Subject: Re: Retention Area Proposed in El Paso County

Hi, I was given you contact information by El Paso County's engineering department. They told me that I'd need to get state approval for a retention area on our site (14655 Davis Road, Peyton, CO 80831). We are not proposing to change the retention area from its existing natural condition very much, in fact, we'd like to not change it at all. I have attached our plans above; The sixth sheet gives an overall view of the site and retention area. I could provide anything else you might need, such as the previously approved drainage report. I left a phone message as well, so please give me a call if you'd like. Thank you,

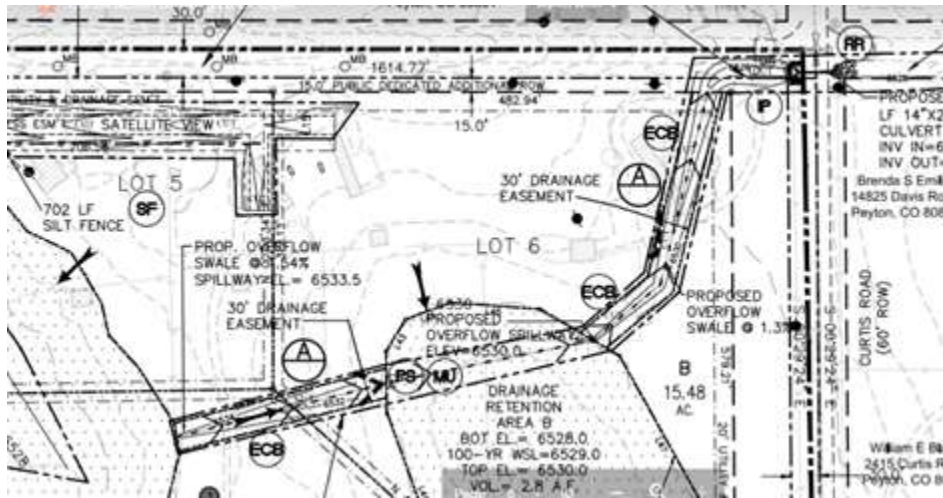
I've attached the historic drainage basin exhibit from the approved drainage report above. It shows two existing sub-basins on the site, each characterized by an existing depression (the hatched areas). Overflows from the existing depressions within the site (if they ever occurred) would drain northeast towards the intersection of Curtis and Davis roads. The developed runoff will follow the historic paths.

We currently have about 92 acre-feet of storage volume in Retention Area A between the 6528 and 6536 contours. Overflows from this retention area would (if they ever occurred) drain to Retention Area B which has another 7 acre-feet of storage volume between the 6528 and 6530 contours. Overflows from Retention Area B (if they ever occurred) would drain towards the intersection of Curtis and Davis roads where we plan to install a culvert. No 100-year flows would reach this point because of the substantial existing retention area in either the existing or proposed conditions so this culvert is only designed to convey flows beyond the 100-year flows.

I guess I need better understanding then. A quick look about spillway elevations, drainage retention areas, volumes of 2.8 AF, etc. gives me the initial impression that some

kind of earthwork will cause some ponding of water whether intended as temporary detention or permanent retention. I guess I need further clarification from you then to firm up the understanding. I don't have the full topo, is it all below grade 2.8 af of retention?

If, as design engineer, you are telling me that there will be no constructed earthen berm at ANY elevation above the existing natural grade to cause temporary or permanent detention of water that builds up any head/pool of water, then it is not a dam. I do not consider a natural depression (if that is what it will remain as) with a natural overflow point to be a dam that create enough buildup of water with potential energy to fail a constructed structure and cause downstream damage.
